FILE NUMBER: Z201-332(KC) **DATE FILED:** August 2, 2021**LOCATION:** Southwest corner of North Riverfront Boulevard and Cole Street.**COUNCIL DISTRICT:** 6 **MAPSCO:** 44 H**SIZE OF REQUEST:** Approx. 1.62 acres **CENSUS TRACT:** 0100.00

REPRESENTATIVE: Jackson Walker LP (Bill Dahlstrom)**APPLICANT:** Bird's Opening, LLC**OWNER:** Ewing Properties, LLC**REQUEST:** An application for 1) a new subdistrict; and 2) a Specific Use Permit for Indoor Athletic and Entertainment Center use on property zoned Subdistrict 1A within Planned Development District No. 621, the Old Trinity and Design District.**SUMMARY:** The purpose of the request is to reduce the required parking and require an SUP for the proposed Indoor Athletic, and Entertainment Center use and for an SUP to allow for the Indoor Athletic and Entertainment Center.**CPC RECOMMENDATION:** **Approval** of the new subdistrict, subject to a revised development plan, a landscape plan, and conditions; and **approval** of the Specific Use Permit for a seven-year period, subject to a revised site plan and revised recommended conditions.**STAFF RECOMMENDATION:** **Approval** of the new subdistrict, subject to a development plan, a land

CPC RECOMMENDED DEVELOPMENT PLAN

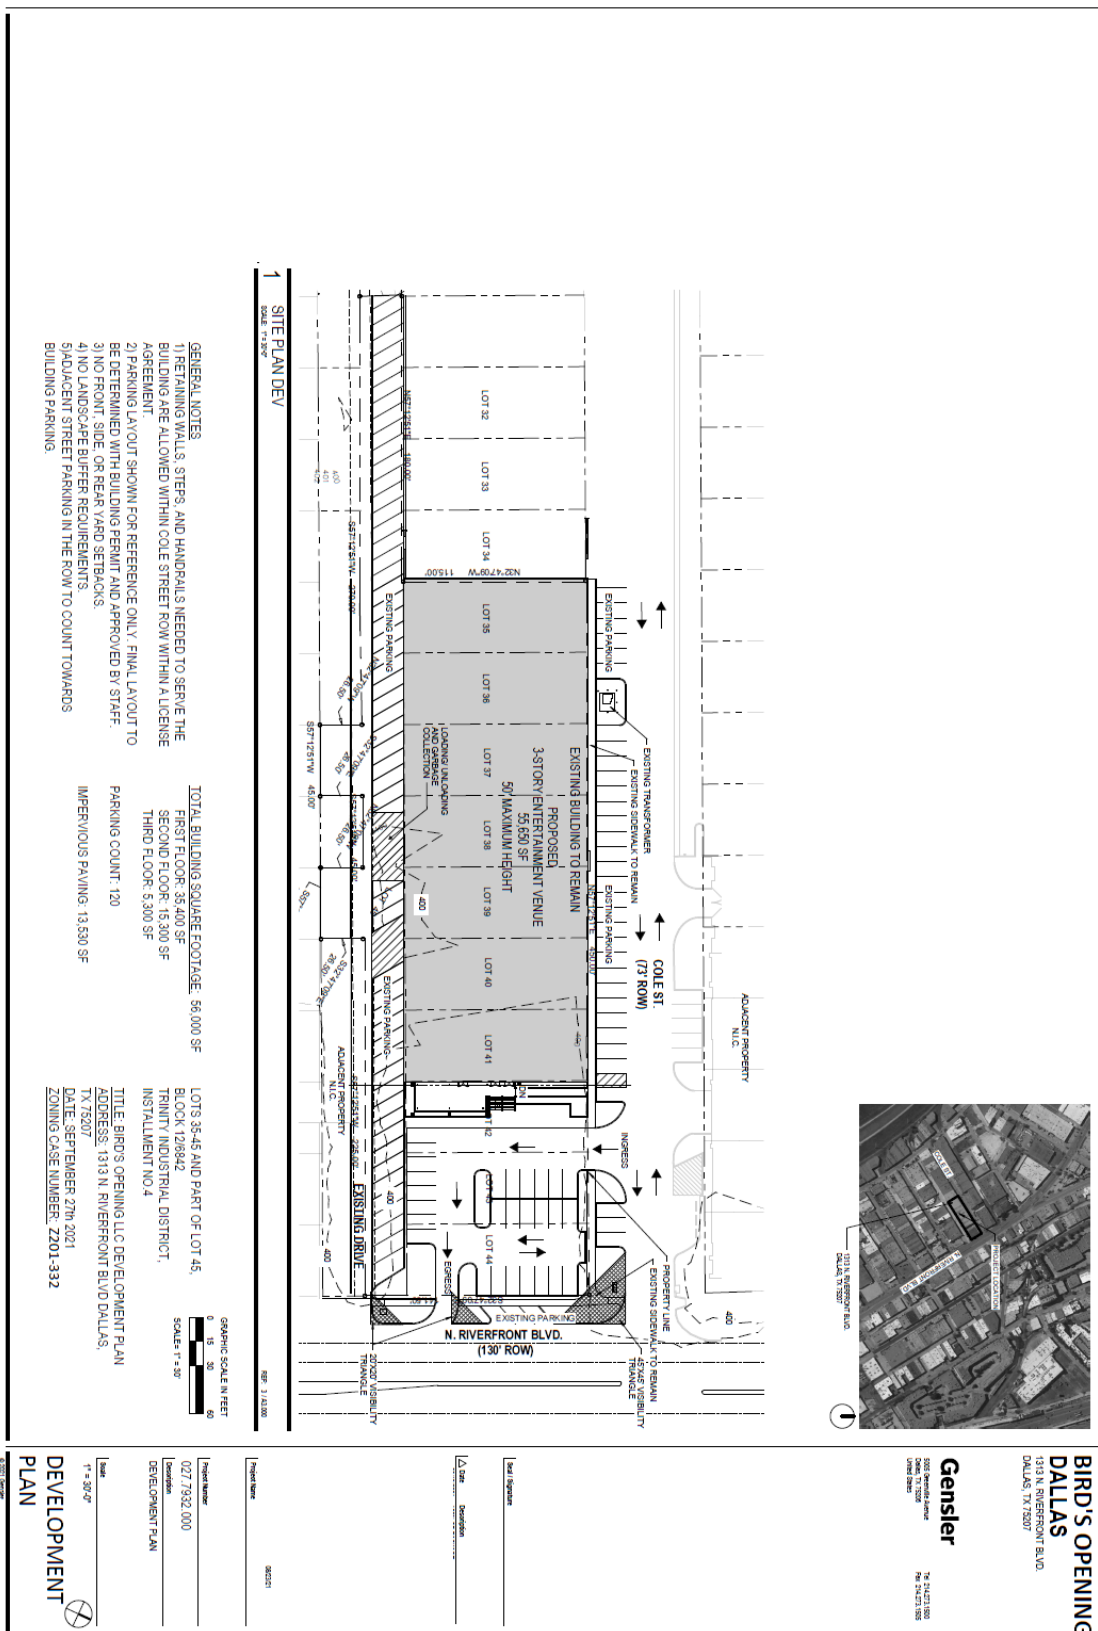
- Plans must comply with ADA sidewalk requirements and provide at least 5-ft wide sidewalks while still accommodating adequate space for 18-ft indented head-in parking along Cole.

The proposed conditions allow for this site to not be subject to the site design standards provided in PD 621. Staff does not support the proposed site plan showing the existing sidewalks that are noncompliant to remain. Staff recommends that the site comply with ADA sidewalk requirements and provide at least 5-ft wide sidewalks while still accommodating adequate space for 18-ft indented head-in parking along Cole Street. In addition to the design standards, the conditions allow for the site to not be subject to the screening requirements. Although it is not subject to the requirements, there is still shrubs and street trees provided on the landscape plan to help screen the off-street parking that is being proposed within the parking lot. The landscape plan is providing trees and shrubs

CPC RECOMMENDED LANDSCAPE PLAN

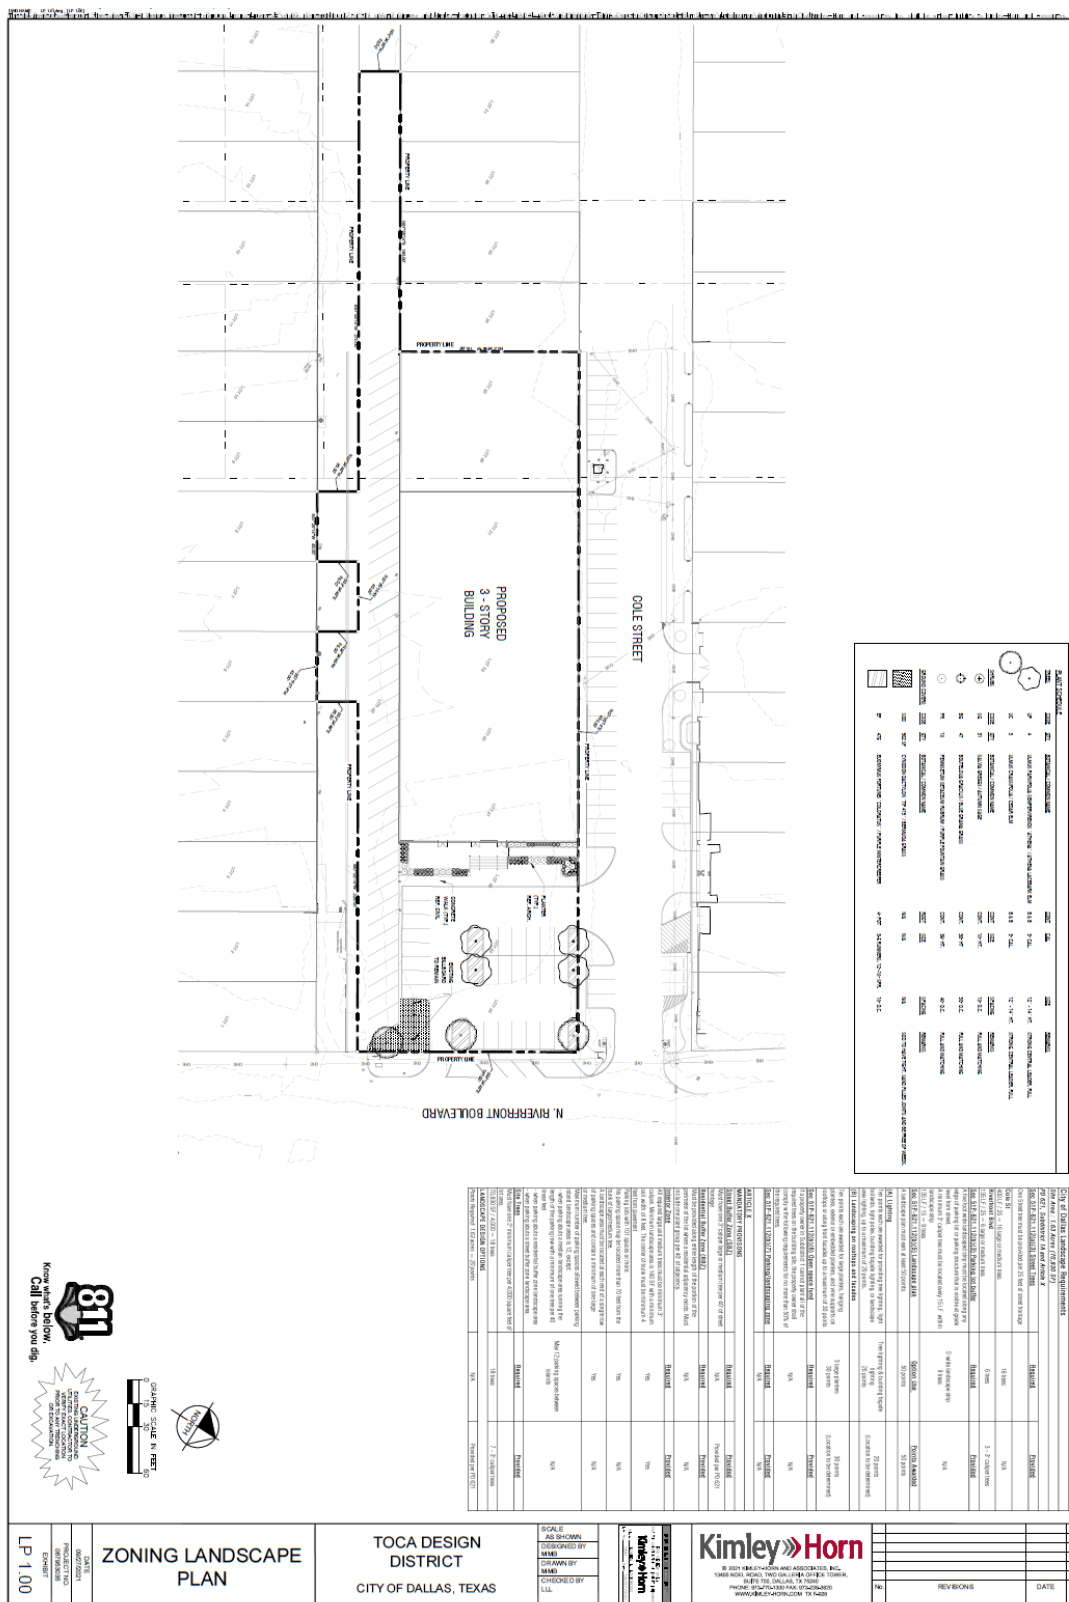
along the street frontages. However, the existing parking along the street frontages are not being screened since they are accessed directly from those streets.

The request includes amending the landscaping requirements to deviate from what is required per the current PD 621 conditions. The landscape plan shows a total of seven trees provided, as opposed to the 18 required. In addition, Cole Street requires 16 street trees along the frontage and Riverfront Boulevard requires six but only two street trees along Cole Street and three street trees along Riverfront Boulevard are provided.

CPC RECOMMENDED SITE PLAN

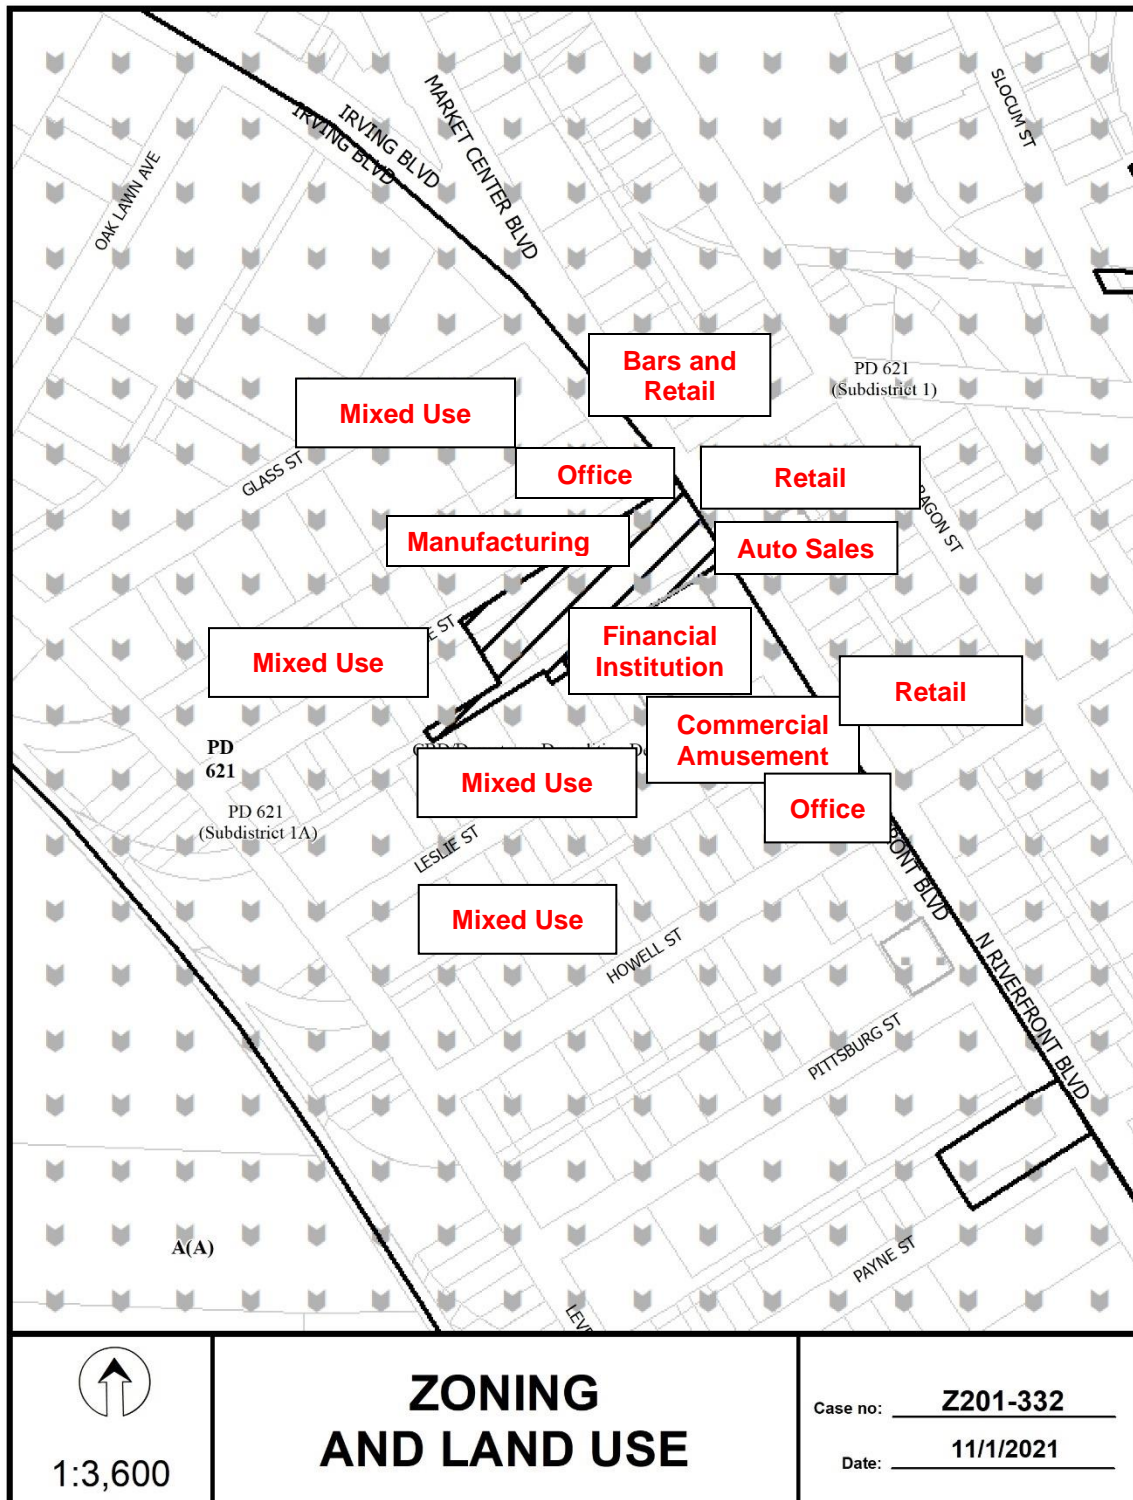
Staff still recommends approval of the proposed development plan and SUP site plan **subject to** the following revisions:
